<b>AMENDMENT OF SOLICITATION/MODIFICATION OF CONTRACT</b>				1. CONTRACT ID CODE <b>J</b>		PAGE OF PAGES <b>1 2</b>	
2. AMENDMENT/MODIFICATION NO. <b>0002</b>		3. EFFECTIVE DATE <b>20 April 2004</b>		4. REQUISITION/PURCHASE REQ. NO.		5. PROJECT NO. (If applicable)	
6. ISSUED BY  <b>U.S. ARMY ENGINEER DISTRICT, ALBUQUERQUE CORPS OF ENGINEERS 4101 JEFFERSON PLAZA, N.E. ALBUQUERQUE, NEW MEXICO 87109-3435</b>		CODE		7. ADMINISTERED BY (If other than Item 6)		CODE	
8. NAME AND ADDRESS OF CONTRACTOR (No., street, county, State and ZIP Code)				<input checked="" type="checkbox"/> 9A. AMENDMENT OF SOLICITATION NO.  <b>W912PP-04-R-0011</b> <input checked="" type="checkbox"/> 9B. DATED (SEE ITEM 11) <b>18 March 2004</b> <input type="checkbox"/> 10A. MODIFICATION OF CONTRACTS/ORDER NO.   <input type="checkbox"/> 10B. DATED (SEE ITEM 13)			
CODE		FACILITY CODE

**PROJECT: DESIGN/BUILD, ARSENIC TREATMENT SYSTEMS, KIRTLAND AIR FORCE BASE, BERNALILLO COUNTY, NEW MEXICO**

1. This is Amendment No. 2 to Solicitation No. W912PP-04-R-0011; 18 March 2004. The following revisions shall be incorporated into the specifications. All other provisions shall remain unchanged.

## DIAGRAM 1

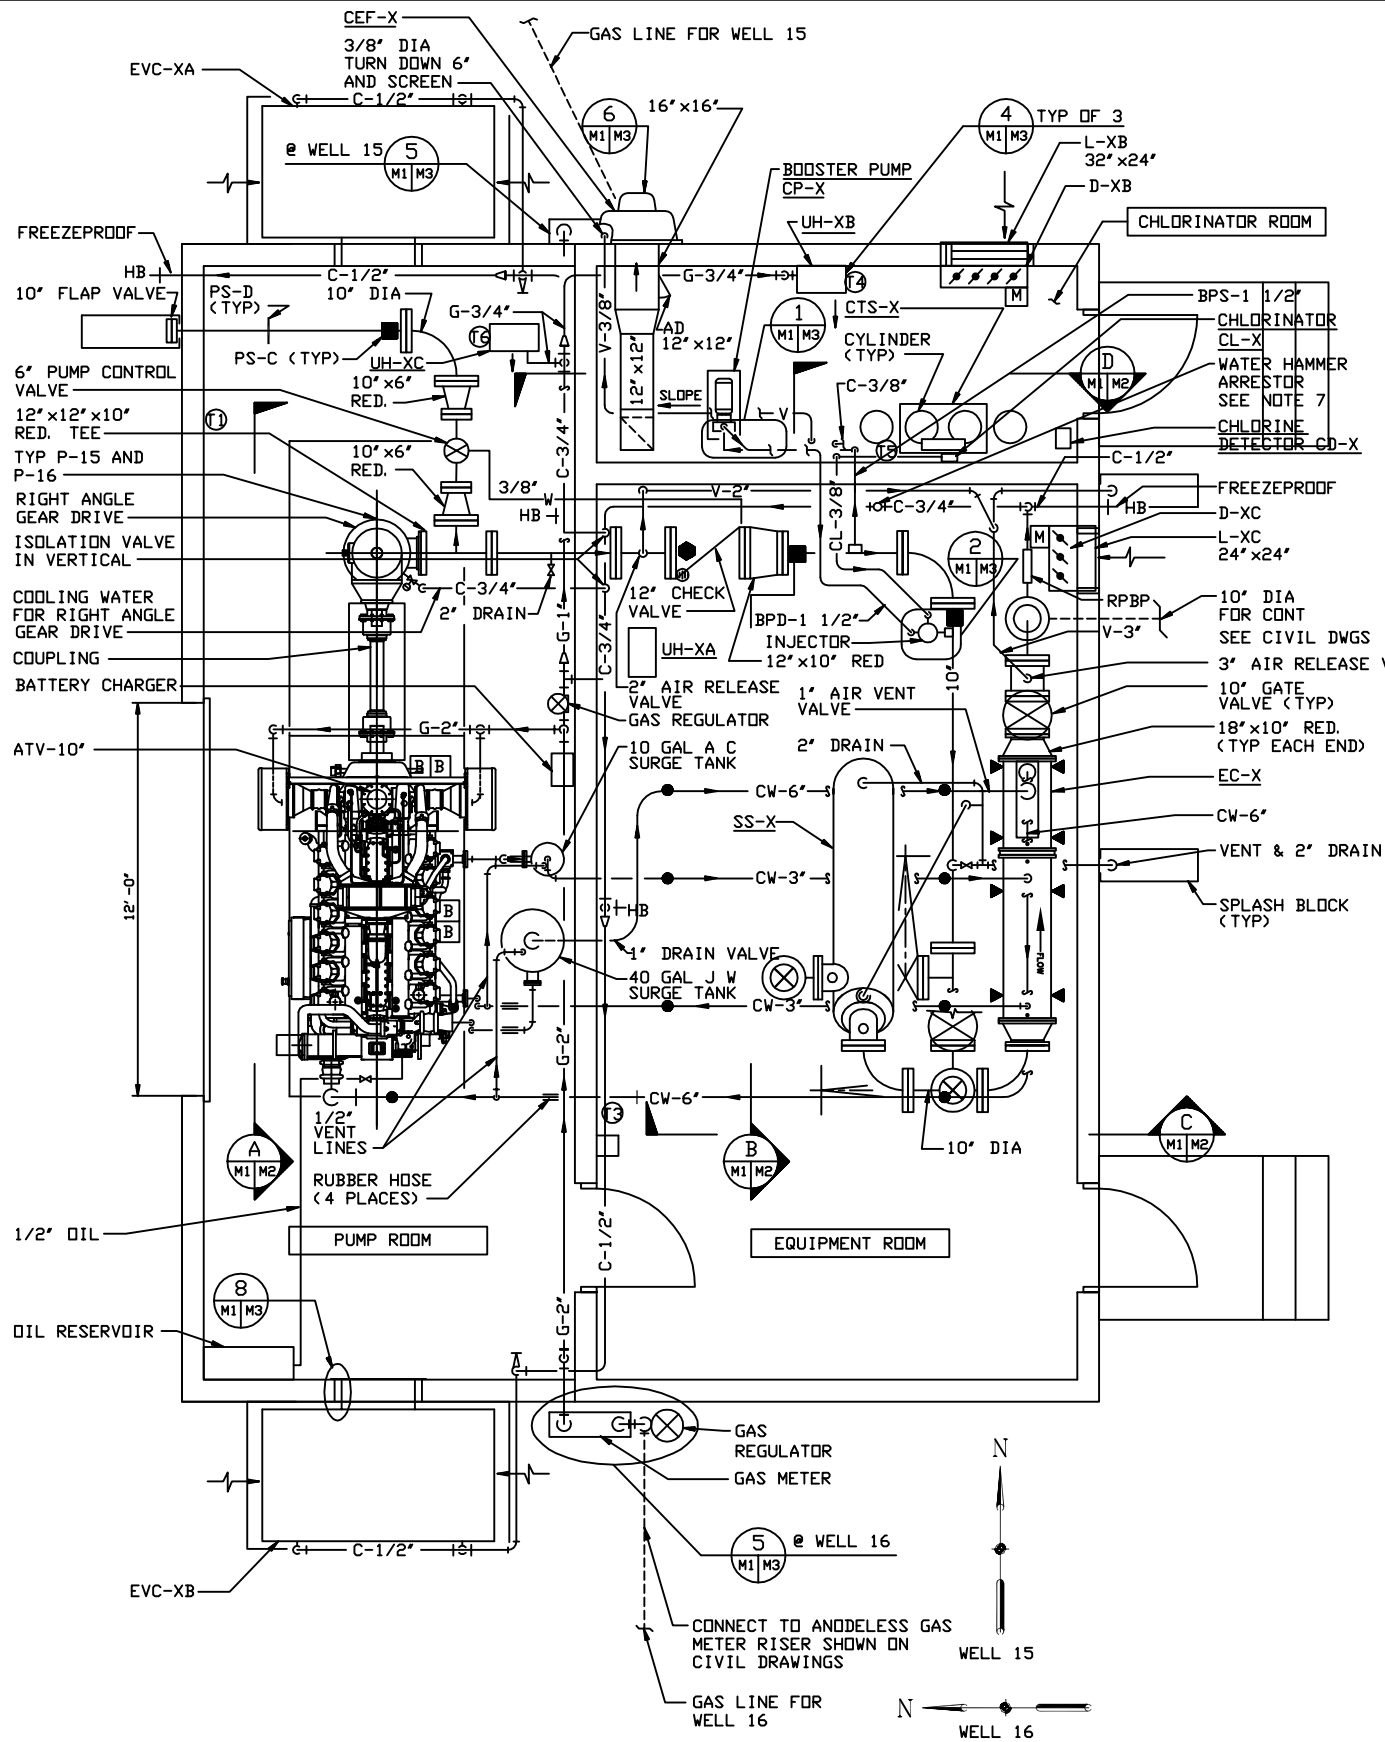
3.7.5 **Auxiliary Water Diversion Line.** The Contractor shall install an 18-inch auxiliary water diversion line as shown conceptually on Diagram 1 in Appendix N. This line will give Base water system operators additional flexibility in operating the system. The Contractor shall determine the optimal routing of this line.
